Date: April 22, 2003  
To: T10 Committee (SCSI)  
From: George Penokie (IBM/Tivoli)  
Subject: Yet More Persistent Reservation Fixes

During an internal review of persistent reservation several errors and inconsistencies were discovered. This proposal points out those areas and suggests corrections to SPC-3 rev 12.

Figure 1 — Device server interpretation of PREEMPT service action

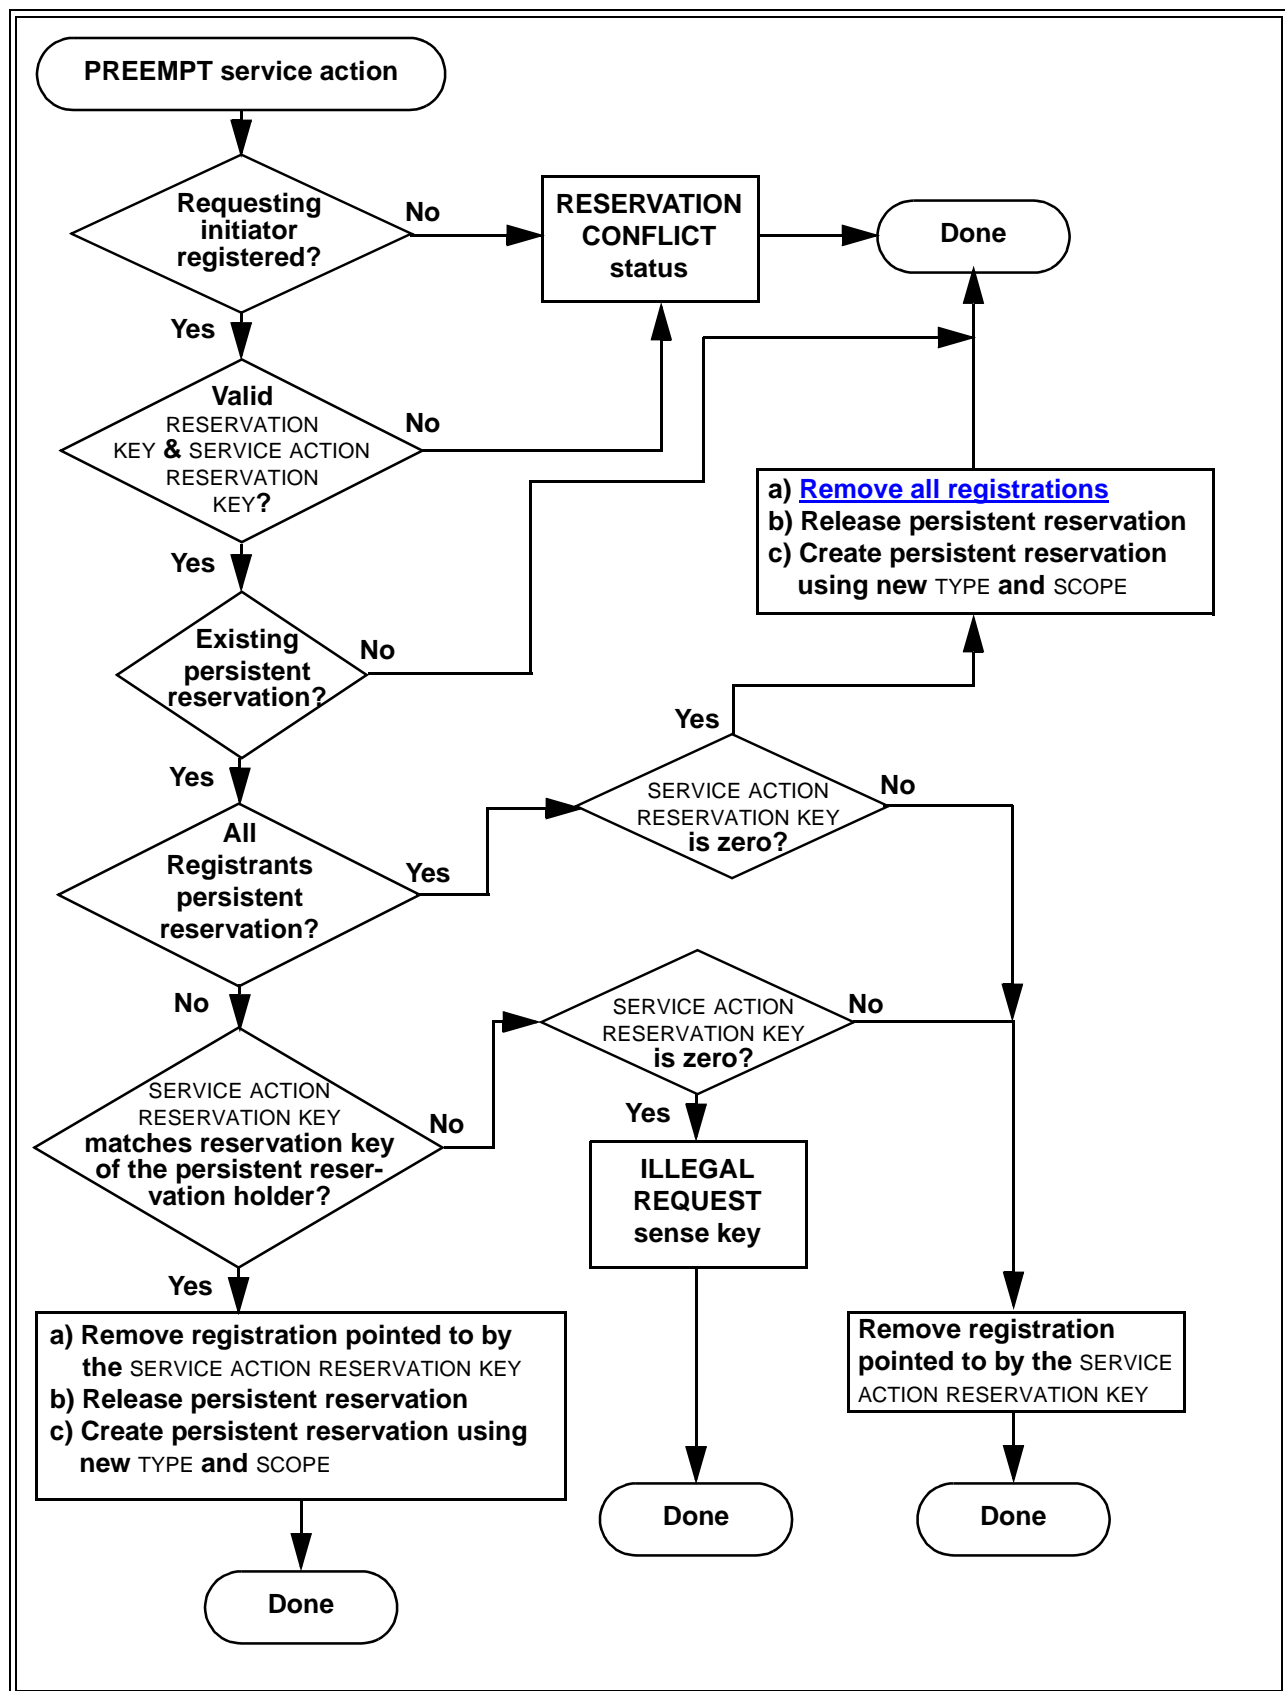
Add the statement << Remove all registrations >> to the flow chart in as shown below.
